CITY OF ALBUQUERQUE

**Planning Department
Transportation Development Services Section**

Re: 4608 Mcleod Rd NE, Traffic Circulation Layout
Engineer's Stamp dated 03-29-06 (F17-D53A)

Re: Bill Ramos Storage Building, 4608 McLeod Road NE, Grading and Drainage Plan

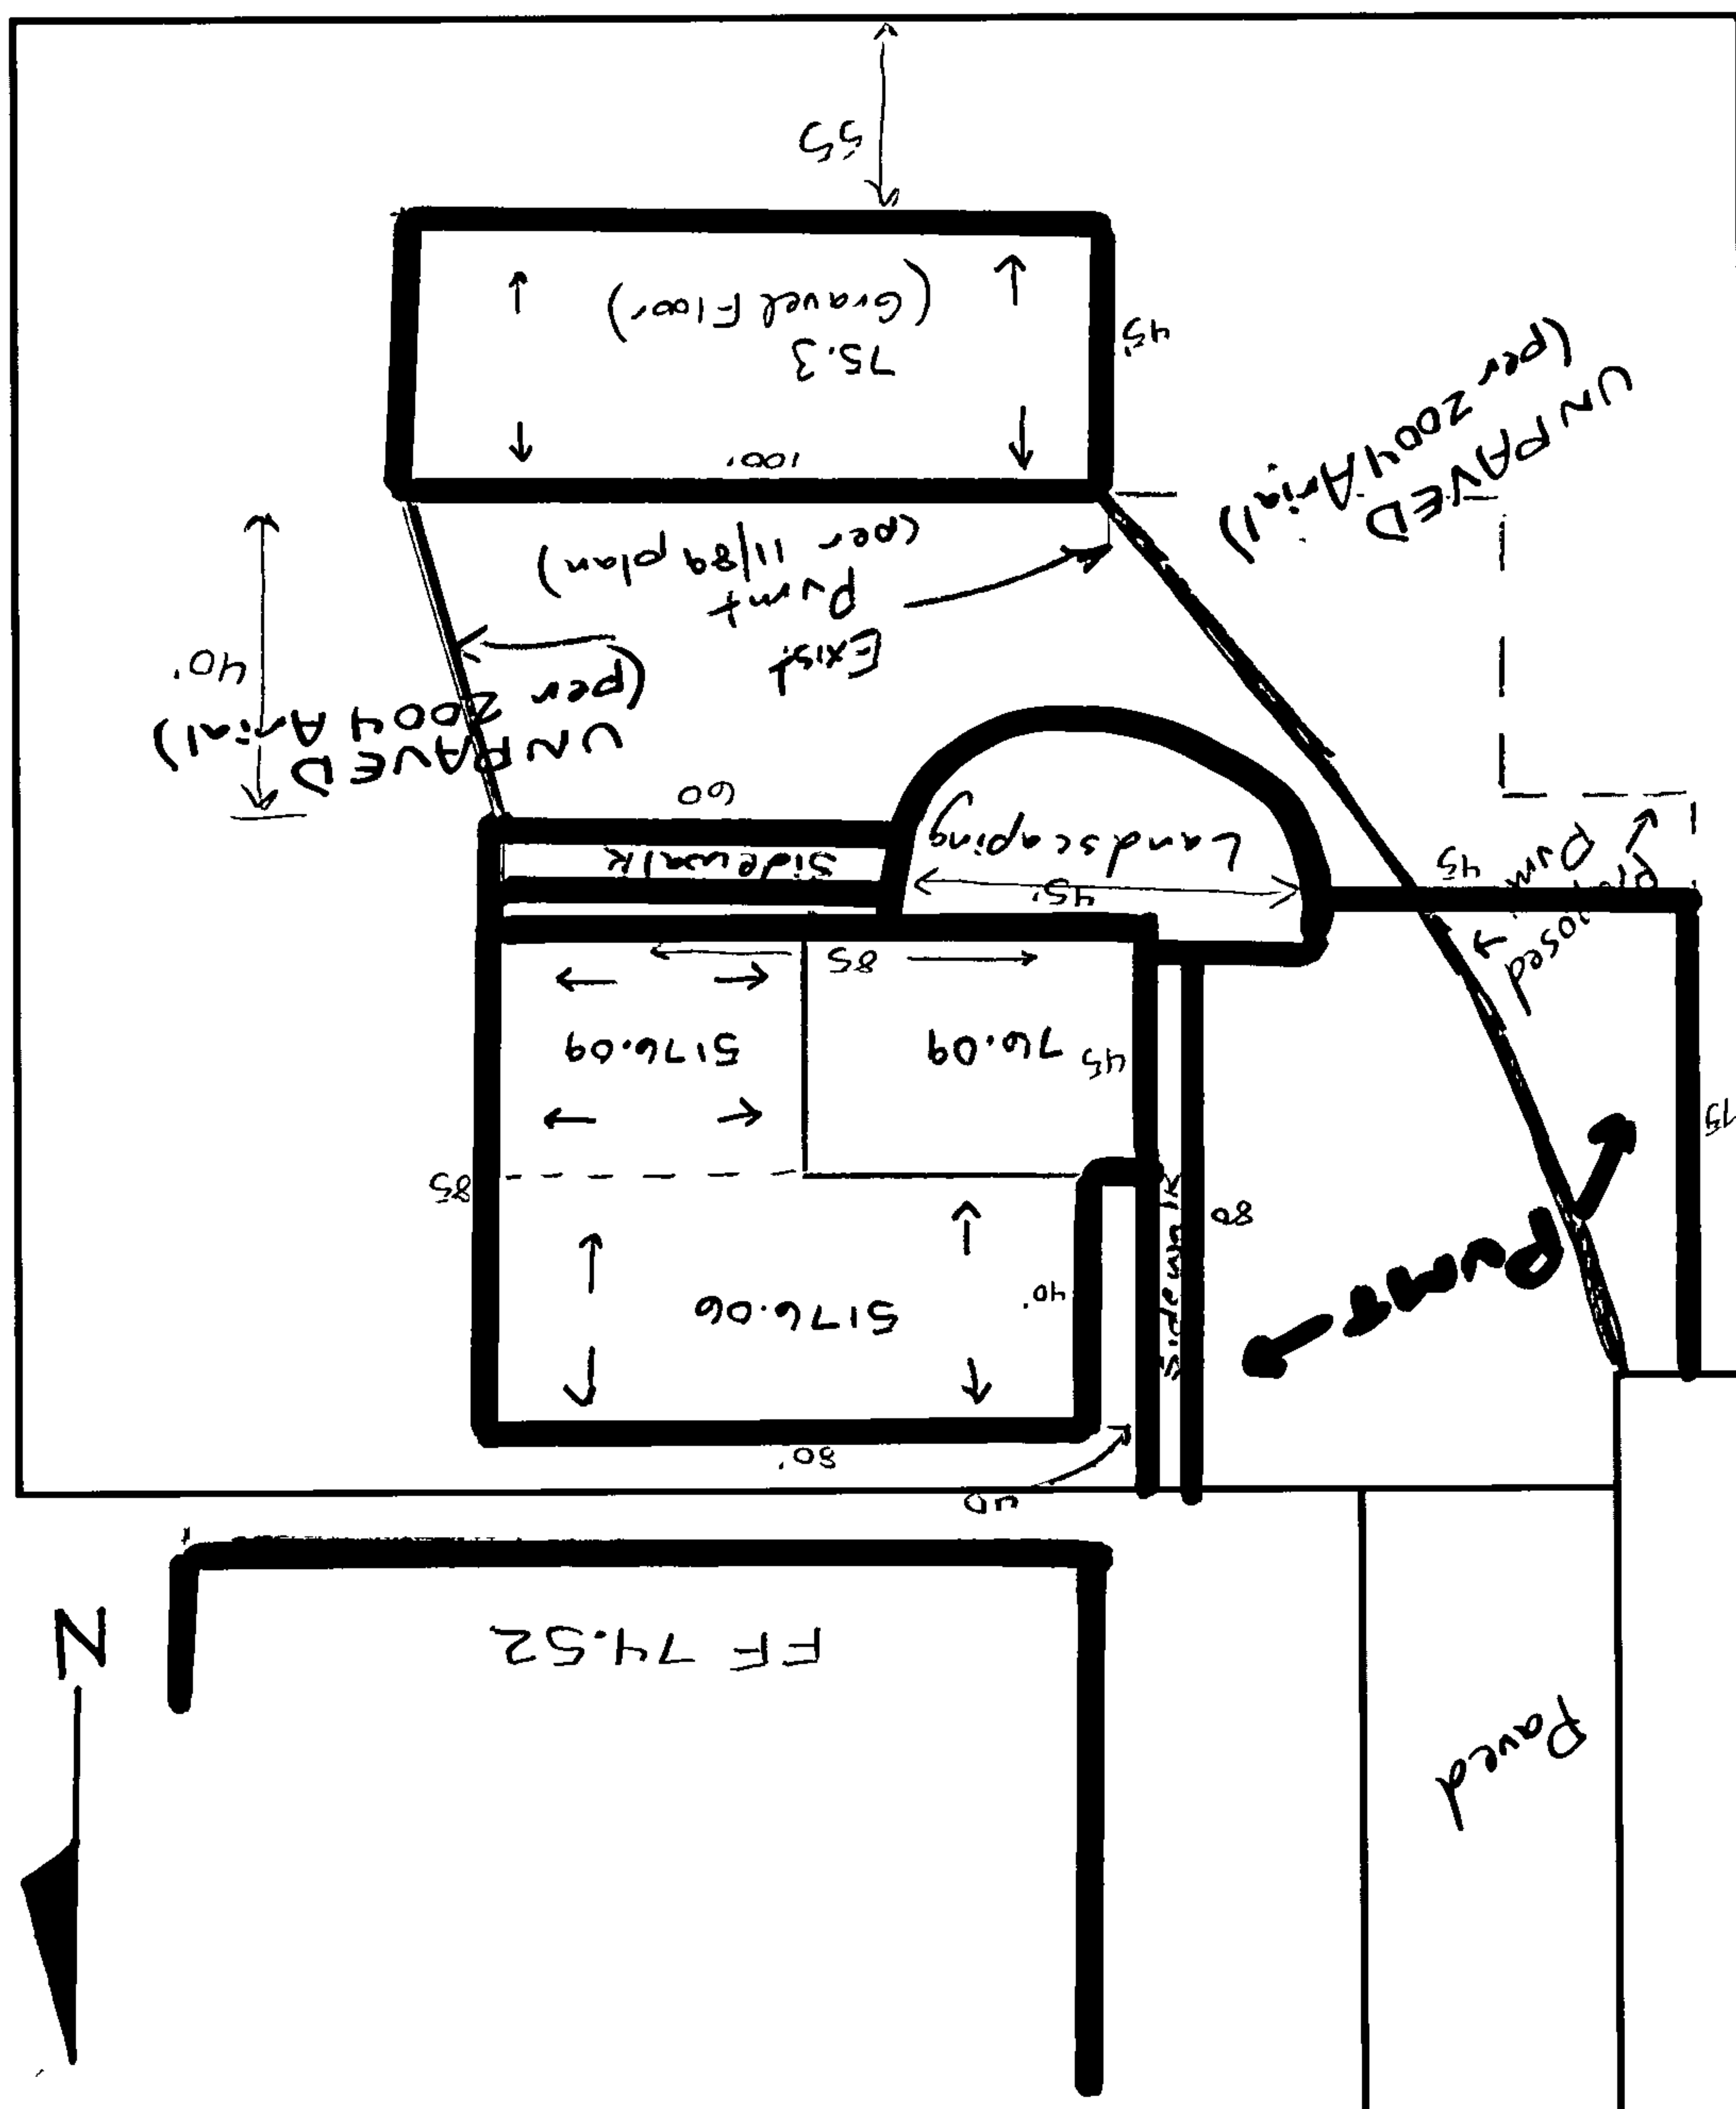
STD. SPECS,
LABEL ALL CURVES

~~8' SW / OR~~

? \Leftrightarrow 8' SW w/ 20' w/ PRK Bumper.

SW. WIDTH @ West SIDE PROPOSED Building

PARKING Calculations Do they need to reflect
all parking provided / or just proposed?

SW. SHOW TRANSITION

WIDTH OF EASEMENT (ACCESS.)

- How DOES EASEMENT TIE INTO MCLEOD § is this easement wide enough for
- TURN AROUND.
- IS A DRIVEWAY PAD AVAILABLE FOR EASEMENT.

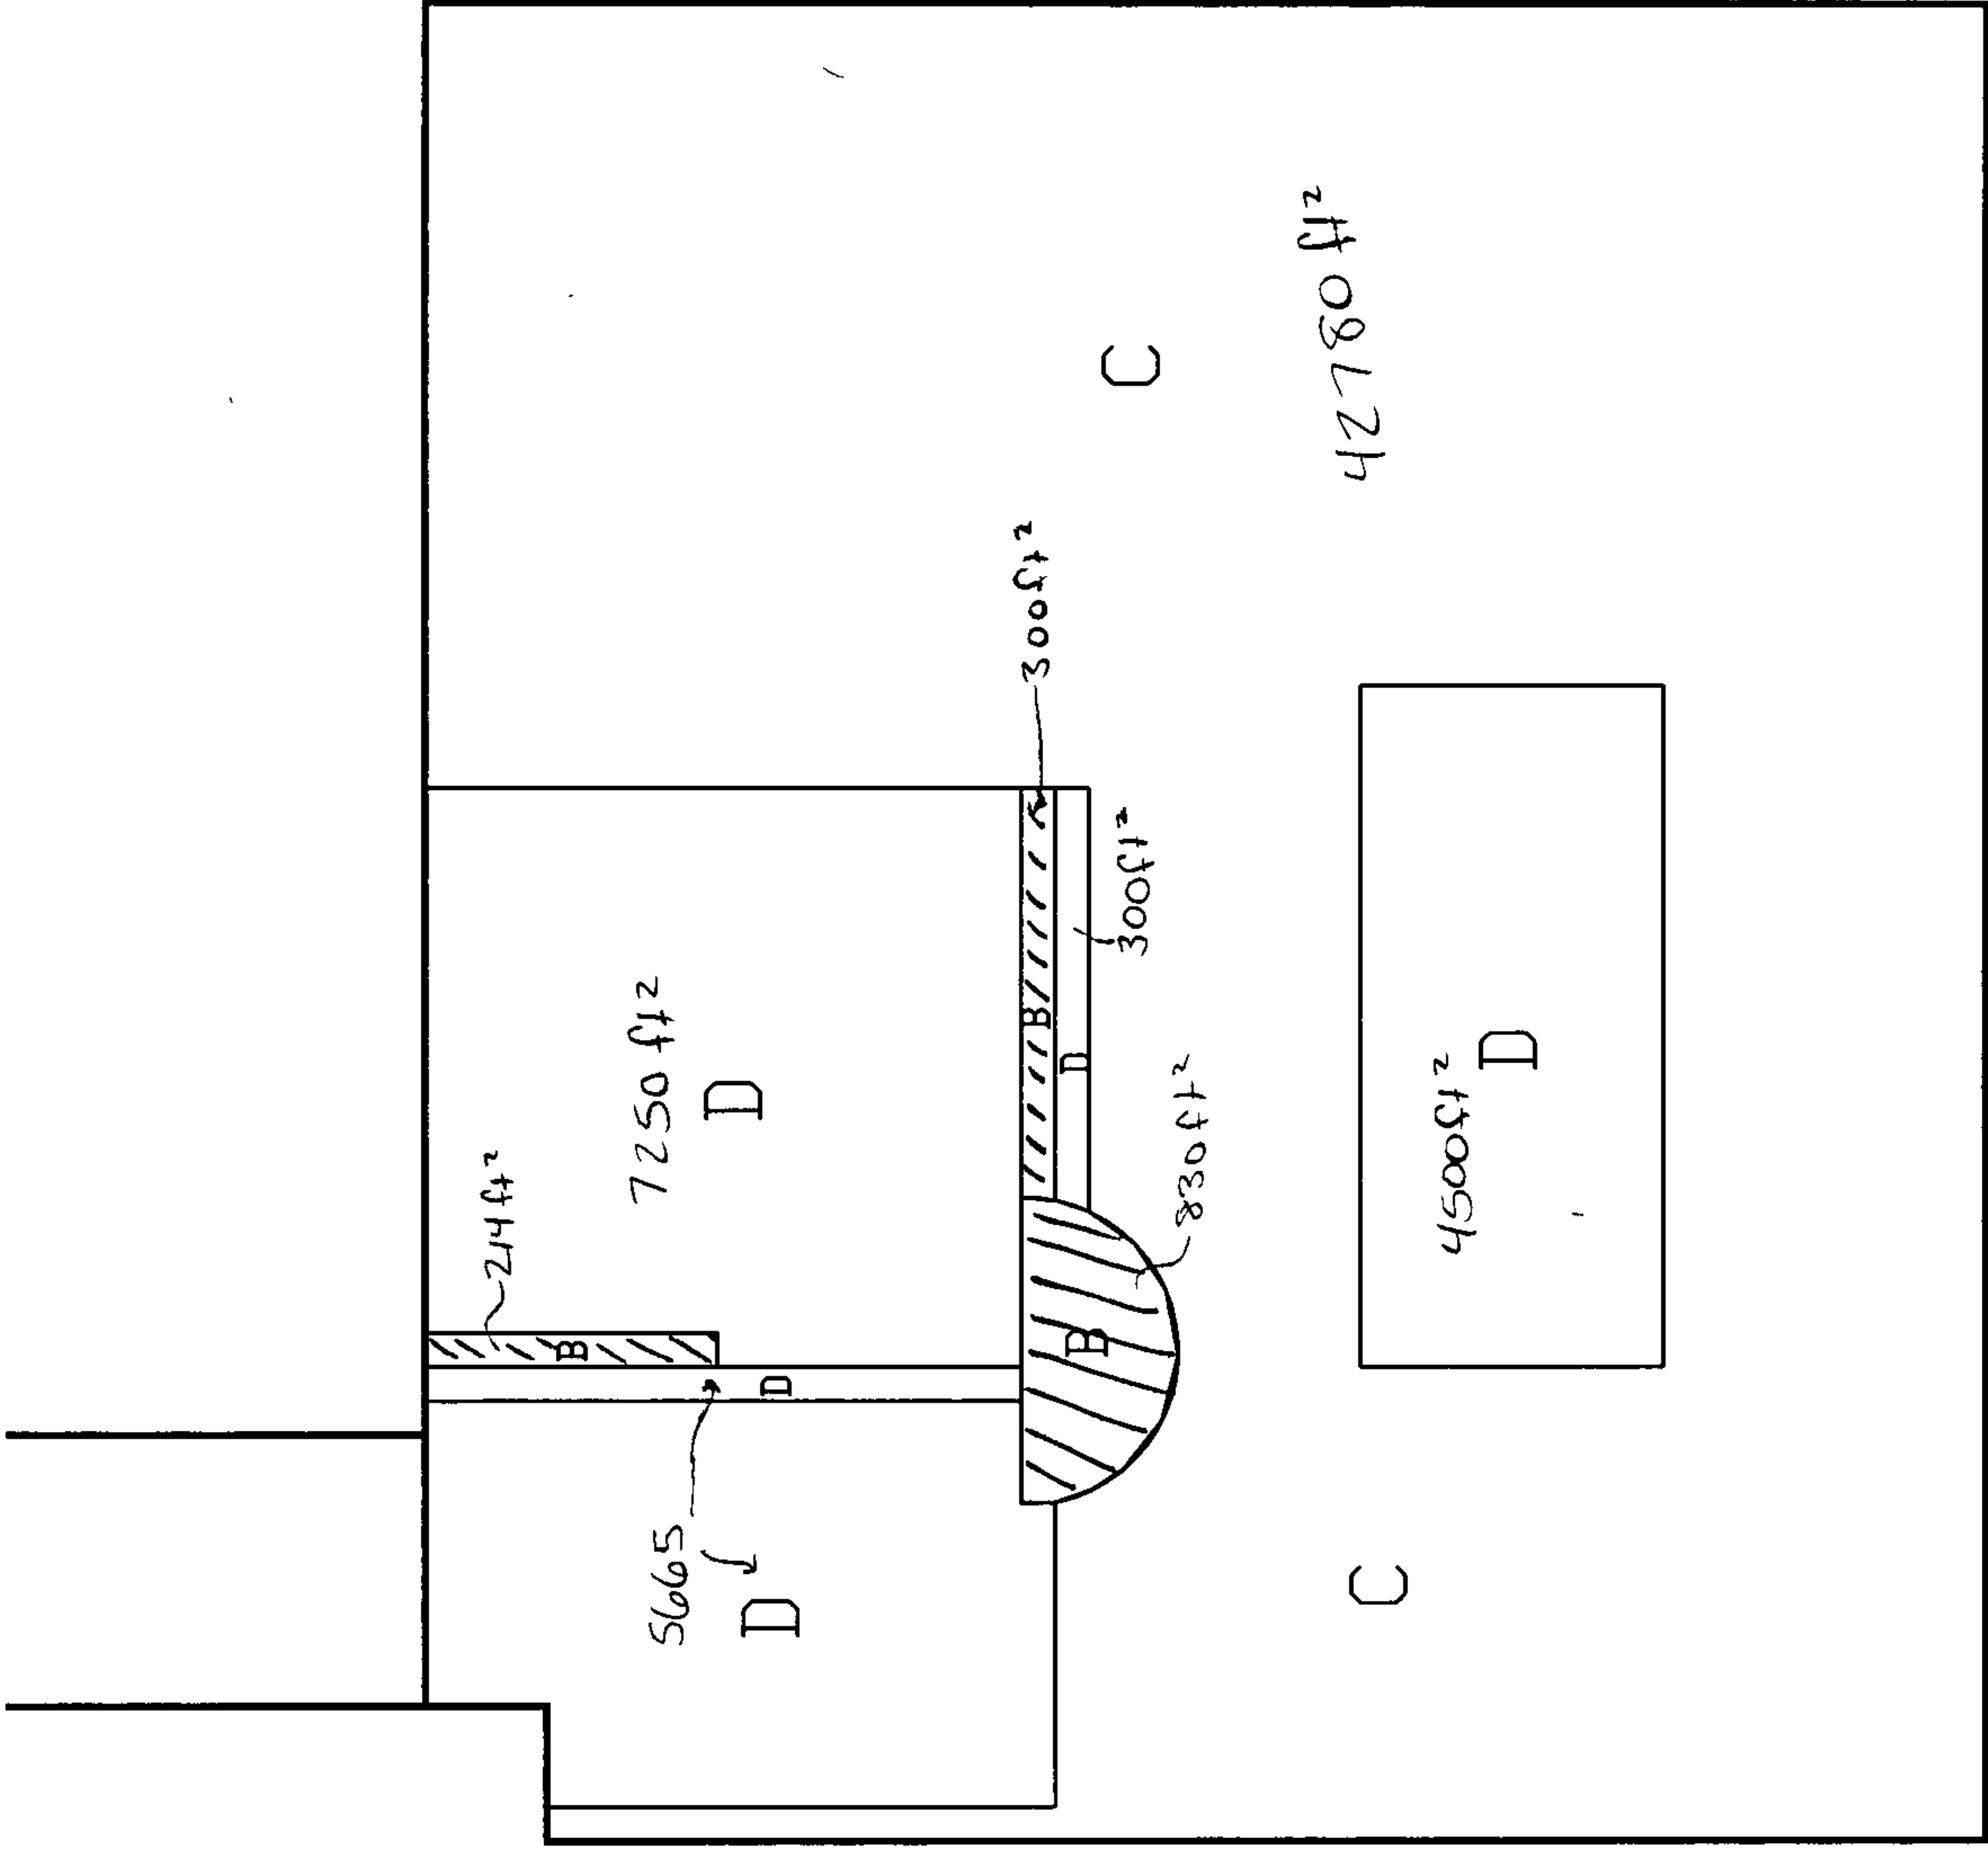
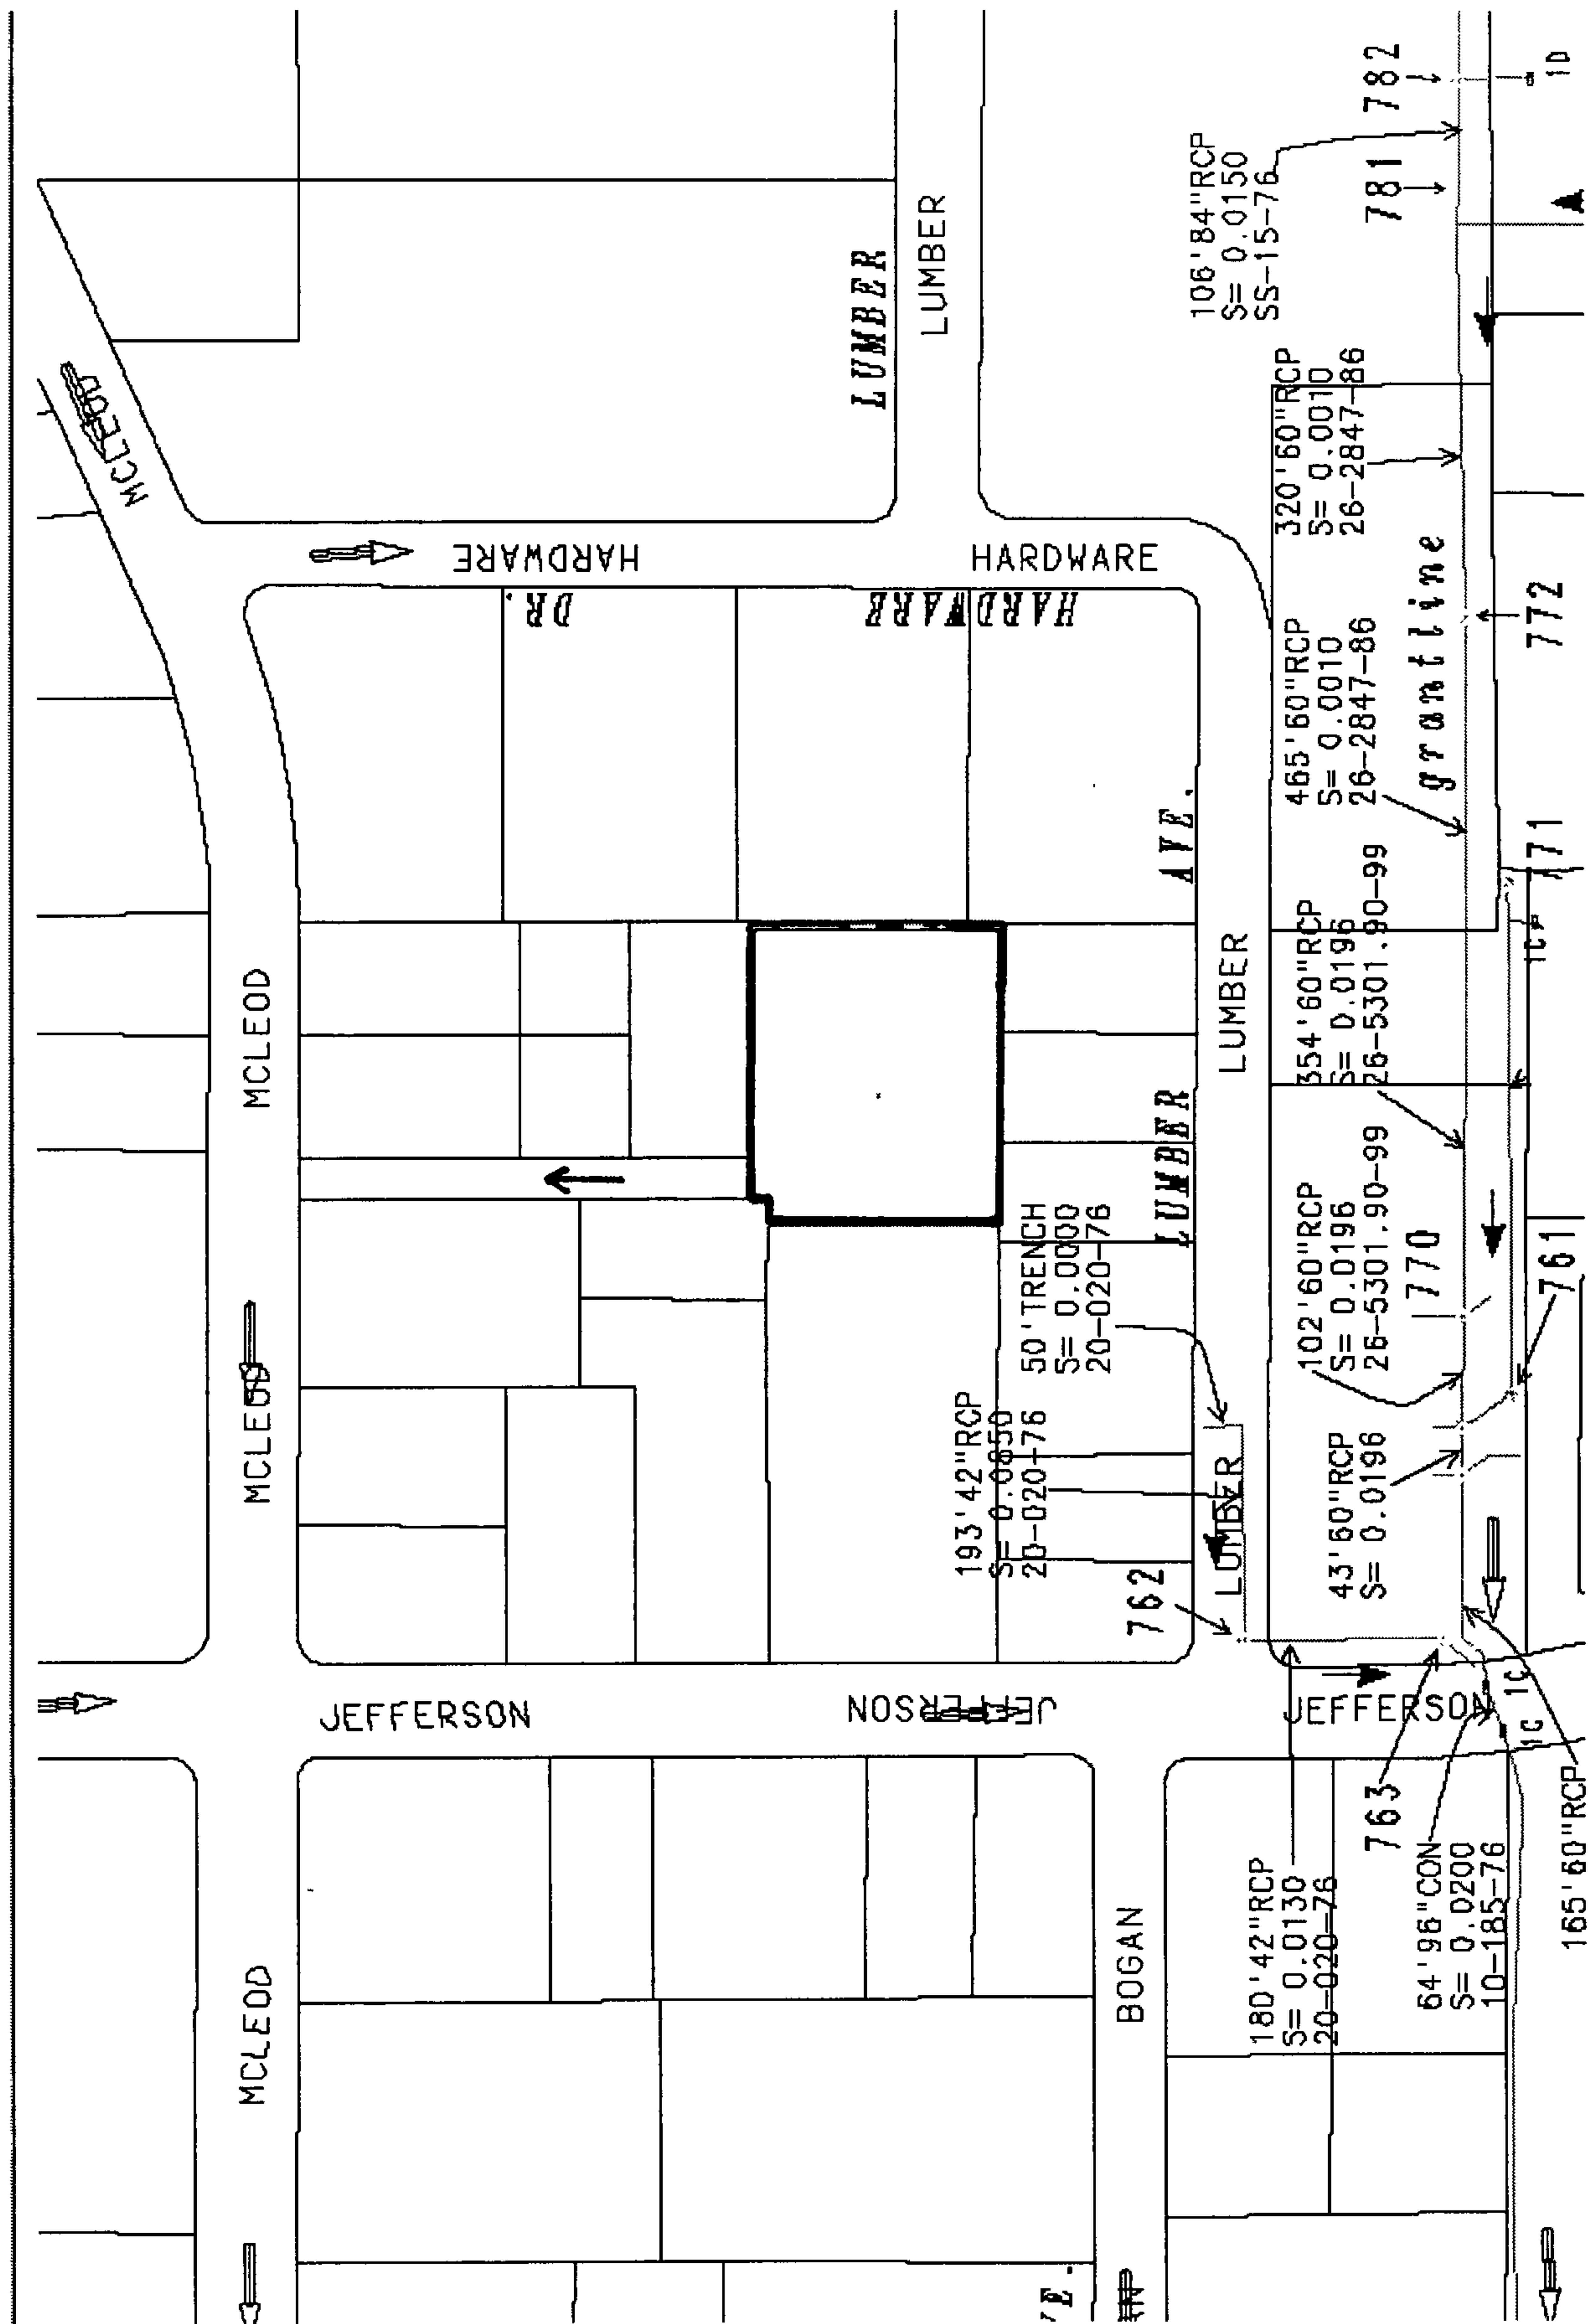
FF
73.80

$$\Sigma = 61839$$

Type B	2%	1344 ft²
Type C	69%	42780 ft²
Type D	29%	17715 ft²
